**CITY OF MENASHA
PLAN COMMISSION
Menasha City Center
100 Main Street, Menasha
Rooms 132 and 133**

**December 7, 2021
3:30 PM**

AGENDA

To: Plan Commission
From: Community Development Department/SS
Date: December 7, 2021
Re: **Special Use Permit and Site Plan Review – TriCity Auto – 1415 Appleton Road (Parcel 6-01651-00)**

10/25/2021 2:04:04 PM

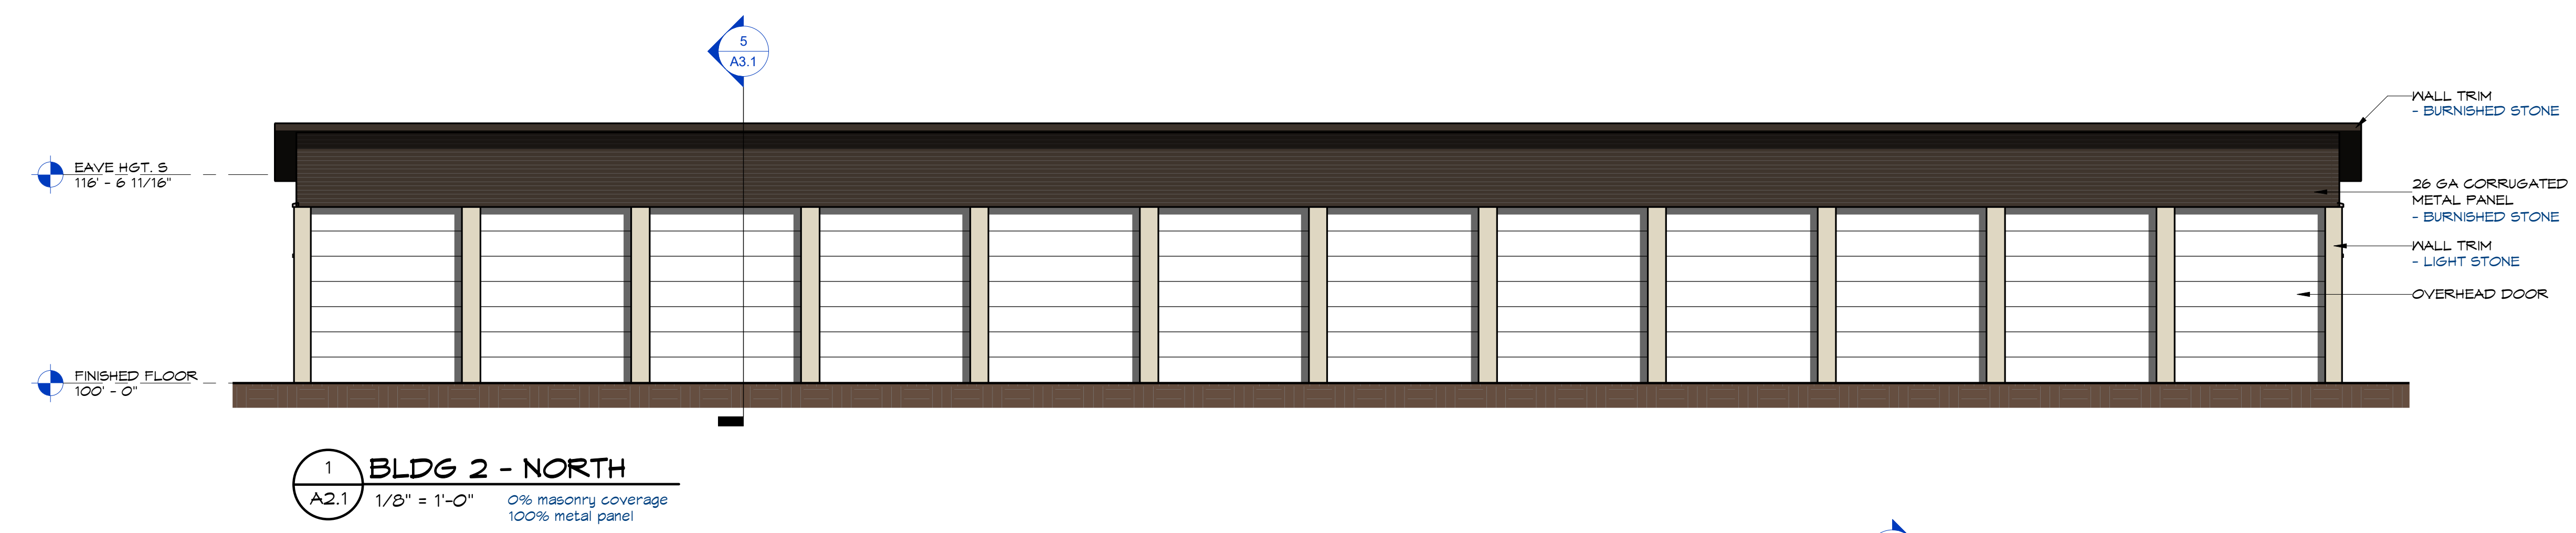
The façade meets the 50% masonry requirement with roughly 65% of the building being masonry block. The remainder of the façade along the roof line is a metal wall panel; however this is over the 25% allowed. The façade will need to be revised to meet requirements outlined in Sec. 13-1-12(f).
